# CRG | Madison Park + Regent

## Urban Design Commission Submission for Approval

# Letter of Intent

## Park & Regent Apartments

DRAWING TITLE  
NORTH ELEVATION  
PRIVACY  
DRAWING NO.

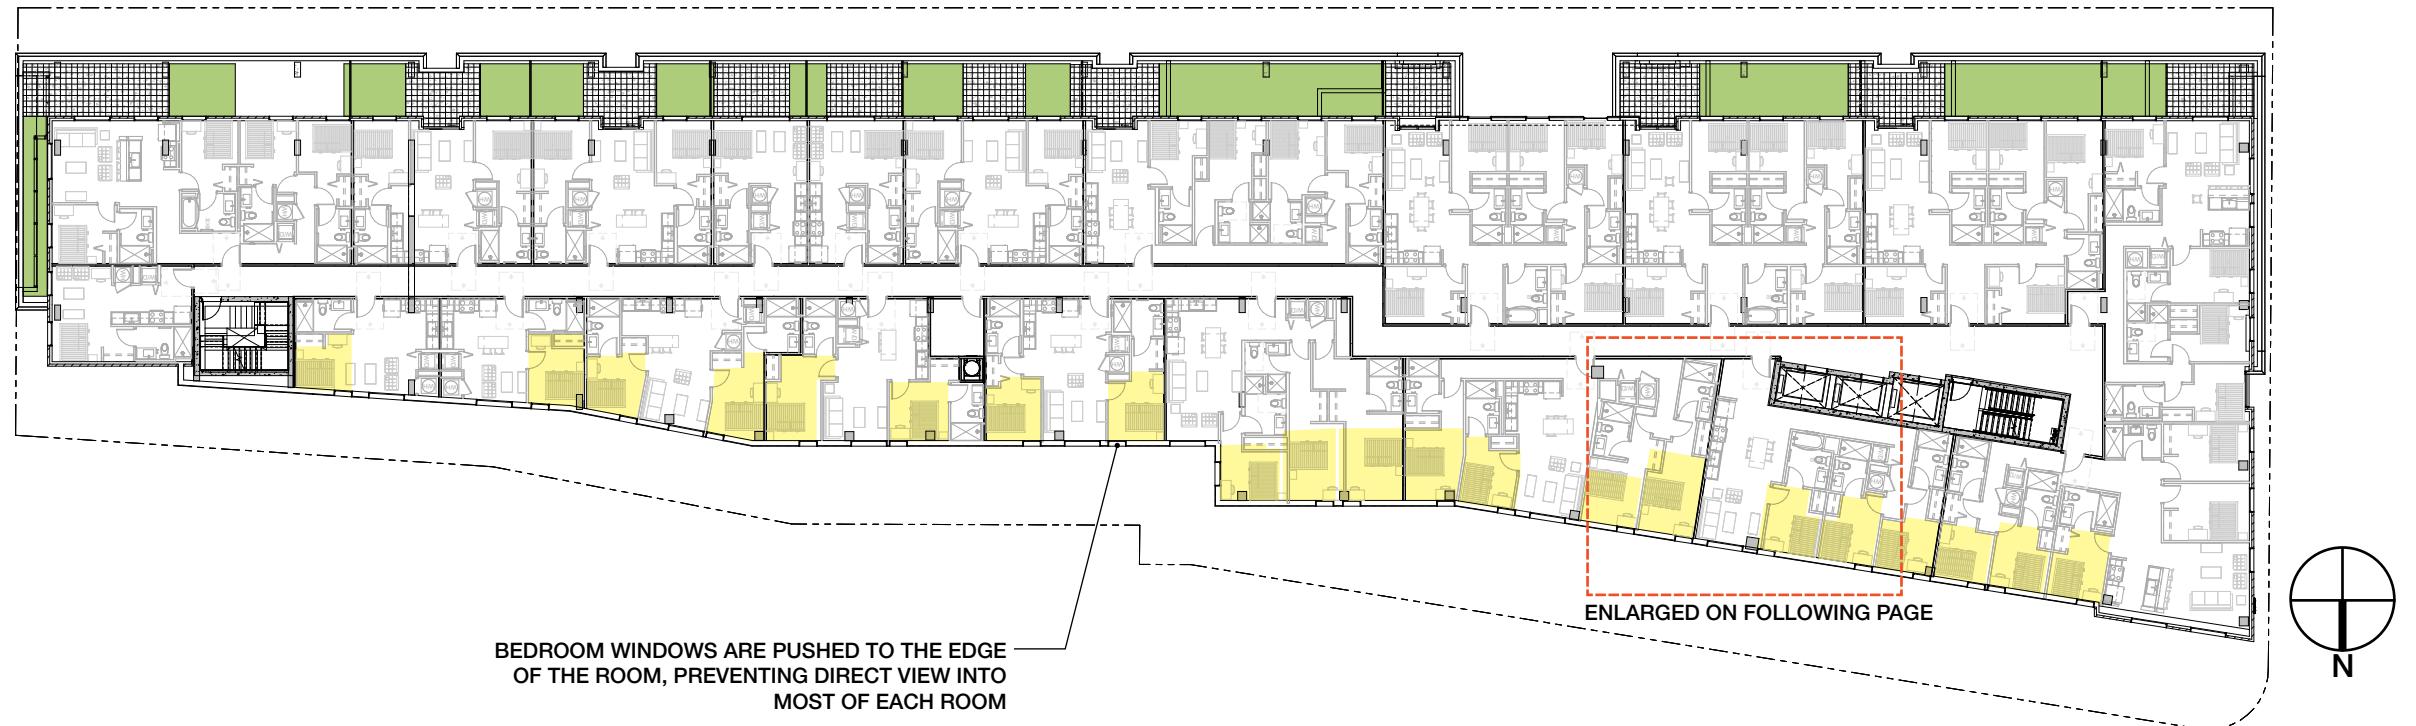
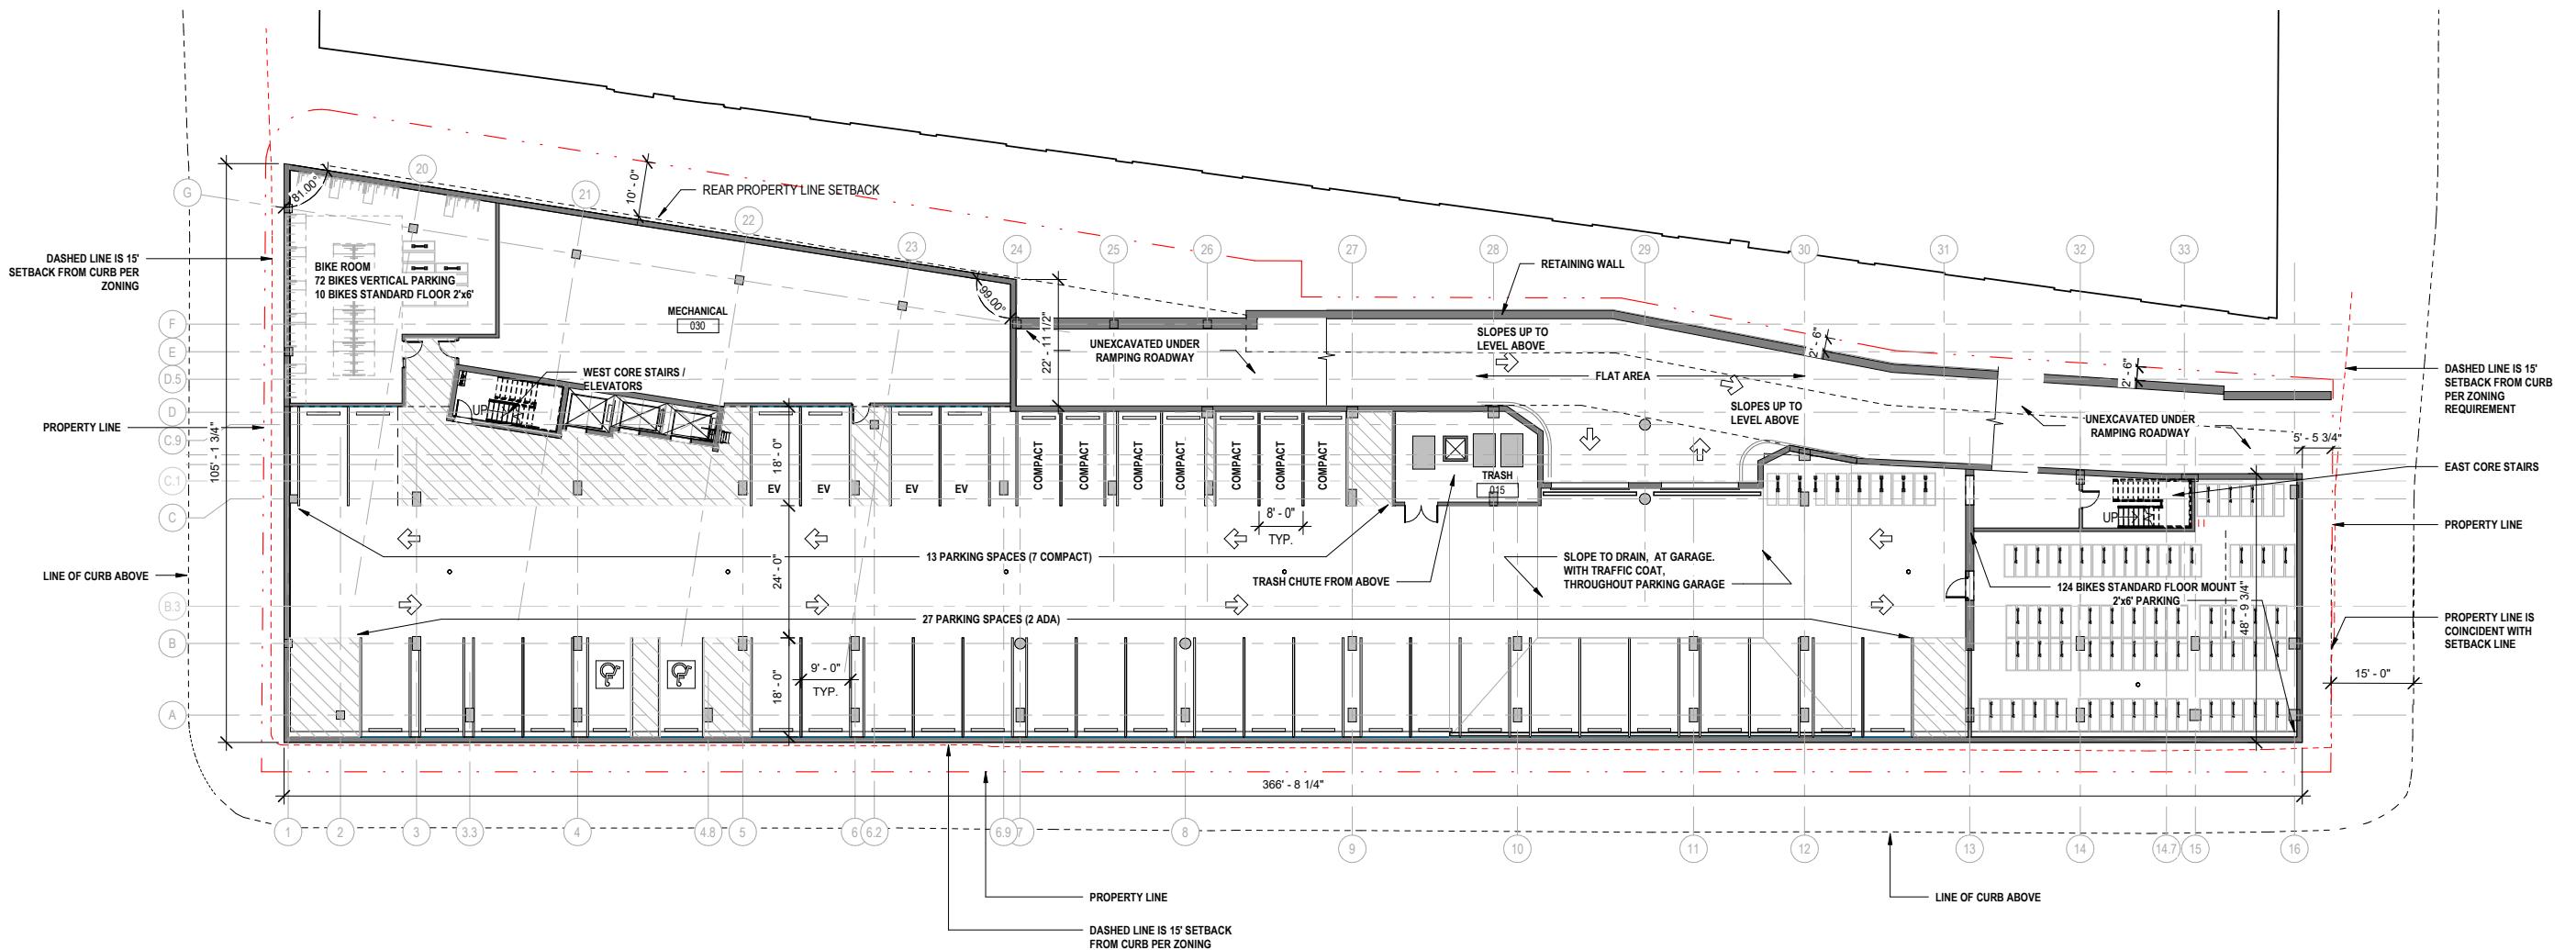
1. To provide for the best privacy possible between the northern units and the adjacent office building, bedroom windows were narrowed and pushed to the foot-wall end of each bedroom. This allows for bedrooms to have ample daylight but prevents any direct view from the offices to any bed, allowing privacy for residents and office occupants. Living rooms have wider windows but benefit from the fact that they are occupied most often during after-office hours. (Illustrations shown on pages UD-15 and UD-16).
